**FLOOR AREA RATIO AFFIDAVIT**  
959 Chestnut Street  
Newton, Massachusetts

TITLE: 959 Chestnut St Newton MA, 02464  
 DATE: 12/10/2019

## **7. 1<sup>st</sup> Floor higher relatively to the garage floor.**

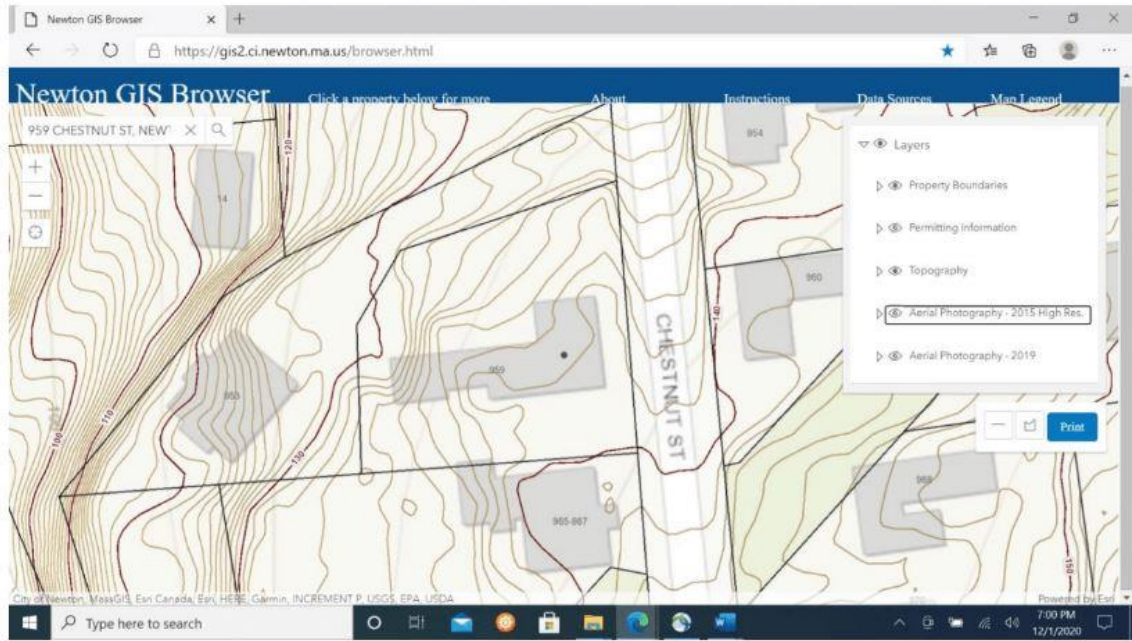
Garage floor is always lower than the first floor. We have 2 steps that lead into the 1<sup>st</sup> floor from the garage. This condition is very standard since garage floor is prone to water, 1<sup>st</sup> floor is required to be higher. I am not sure how this affects the historic district appearance; also this was the reason why we had to install a drainage system for the entire house required my ISD. This is an interior condition and does not affect exterior in any way.

## **9. House height**

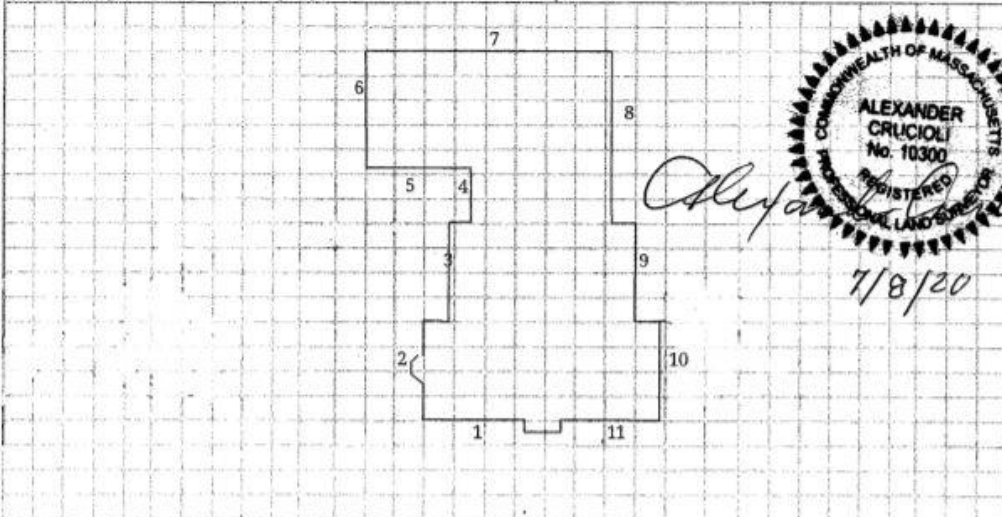
The proposed elevation that was submitted with the original package at ISD should reflect the same house height elevation as the as-built. My understanding is that you have hired a surveyor who should confirm that the elevation grade of the house peak should be the same as what our engineer/surveyor submitted to ISD. This request is outside the requirement by the City Ordinances and state of Mass. There is no need to re-measure your surveyor's measurement. I am not required by any law to hire a surveyor for this request.
